ZedBoard**Digilent**www.zedboard.org

Title	ZEF	Rev	C.1
Circuit	Copyright 2012		
Doc#	500-248		
Engineer	EG		
Author	GMA		
Date	6/20/2012		
Sheet#	1 out of 17

Revision History

Title		ZED	Rev
Circuit	USB and UART	C.1	
Doc#	500-248		Copyright 2012
Engineer	EG		
Author	GMA		
Date	6/20/2012		
Sheet#	7 out of 17

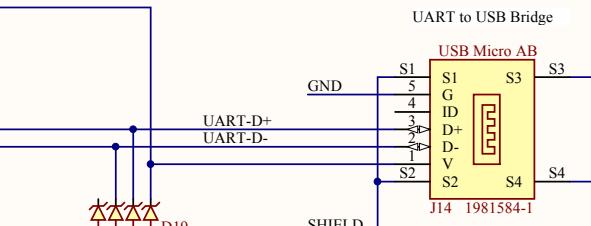
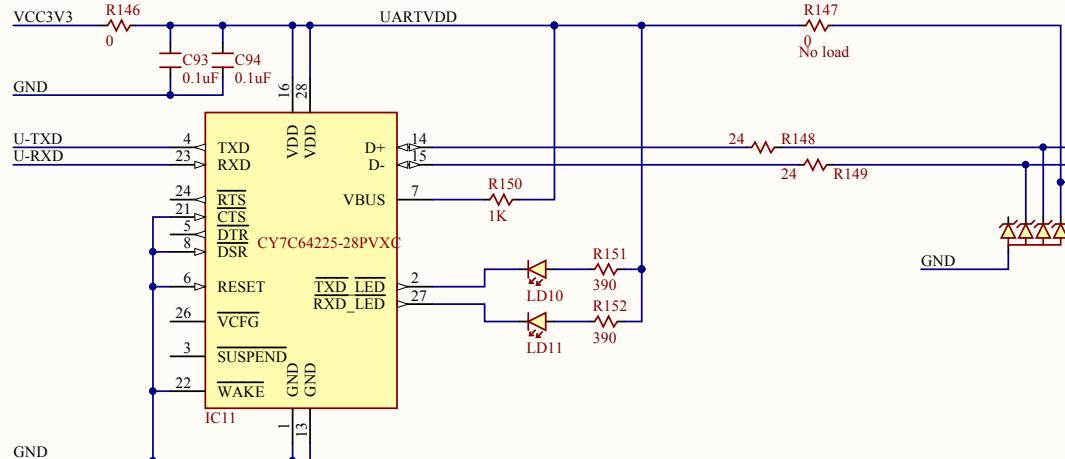
TUSB1210 and Zynq-7000 have a timing incompatibility at hot temperature. Please see the ZedBoard Errata.

Cypress recommends that R150 be connected to J14.pin1 (V). See ZedBoard Errata.

- Sheet 7: Added note regarding USB-UART VBUS connection, that R150 should be attached to J14.pin1 (V)
- Sheet 8: Added reference to heatsink that is now shipped with ZedBoard
- Sheet 10: Added note regarding new SD-CCLK termination recommendation
- Sheet 13: Added note regarding missing DDR3 symbol pins
- Sheet 13: Added note regarding alternative MT41K128M16JT-125:K DDR3 device

- Sheet 7: Added note regarding TUSB1210 and Zynq timing incompatibility at hot temperature

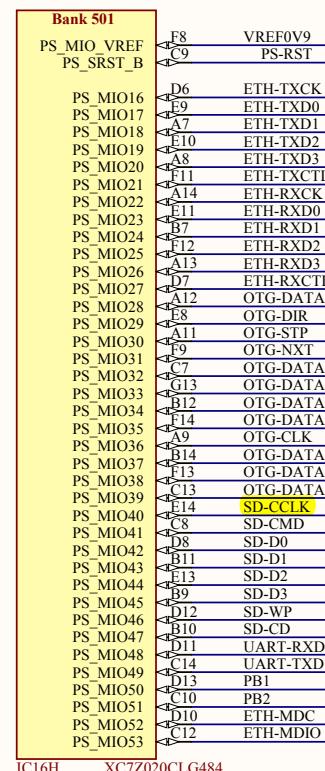
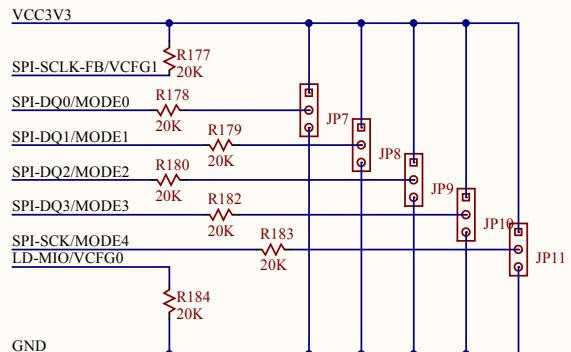
Termination now recommended for SD-CCLK. See ZedBoard errata.

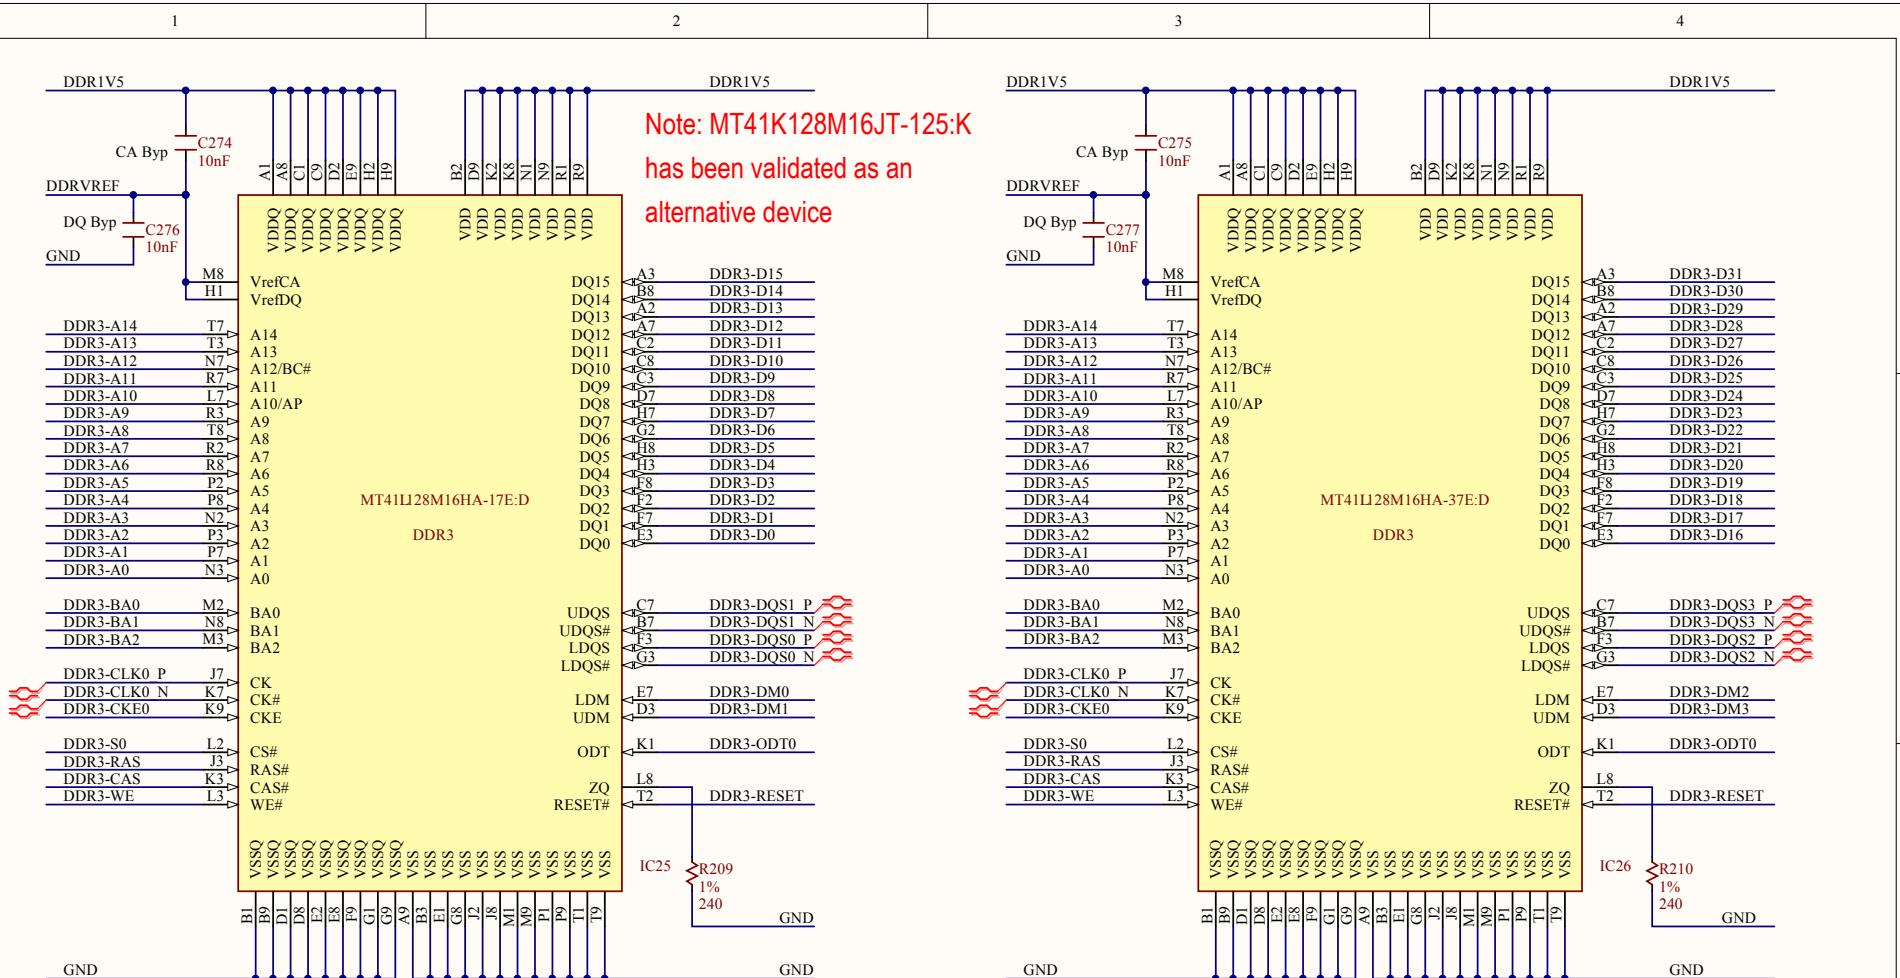
The ZedBoard contains a proprietary USB-JTAG circuit which is obscured on this sheet. This circuit contains IC19, IC20, IC21, IC22, IC23, IC24, JP13, and J17, along with a number of resistors and capacitors. The firmware for this circuit is not publicly available. However, the firmware does come pre-programmed in the SMT2 USB-JTAG module available from Digilent and Avnet. For more information, please see

- Sheet 12: Replaced proprietary JTAG circuitry, which cannot be duplicated, with a black box for reference and a URL to the module equivalent JTAG-SMT2.

Title	ZED	Rev
Circuit	DDR3 Memory	C.1
Doc#	500-248	Copyright 2012
Engineer	EG	
Author	GMA	
Date	6/20/2012	
Sheet#	13 out of 17

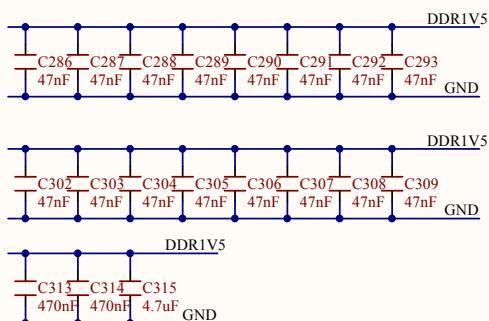
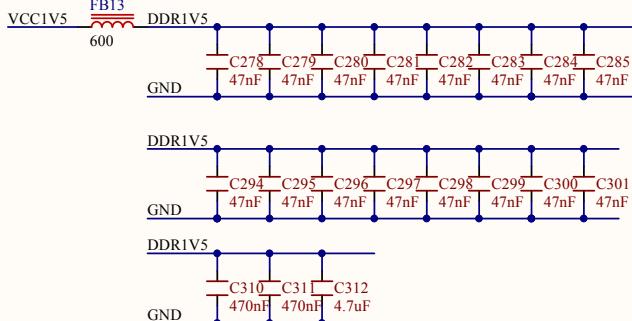
The DDR3 symbol used in the Rev C ZedBoard has a mistake that improperly leaves Pins F1 and G7 disconnected. This affects IC25 and IC26. See ZedBoard Errata.

- Sheet 1: Corrected ZedBoard and Digilent typos
- Sheet 13: Modified IC25, IC26 part number to MT41J128M16HA-15E:D to match BOM
- Sheet 13: Added note regarding new CKE pull-up recommendation
- Sheet 16: Modified C374 capacitor value to be 10uF to match BOM
